UCEN Hub Remodel: Ceramic Tile & Cultured Stone
Project No. FM070003SR/987656
Addendum No. 1

ADDENDUM NUMBER 1

UCEN HUB REMODEL:
 CERAMIC FLOOR TILE AND
 CULTURED STONE SURFACES

AD-2

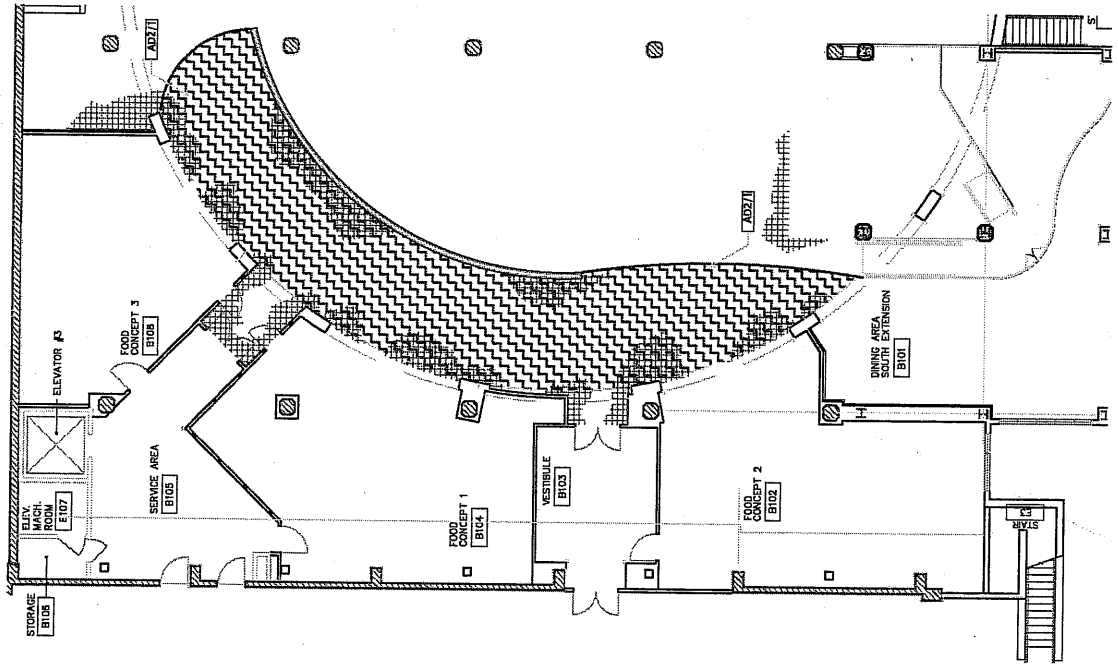
AD271 AREA OF CERAMIC TILE WORK TO BE DONE AS PER ATTACHED SCHEDULE S-1.
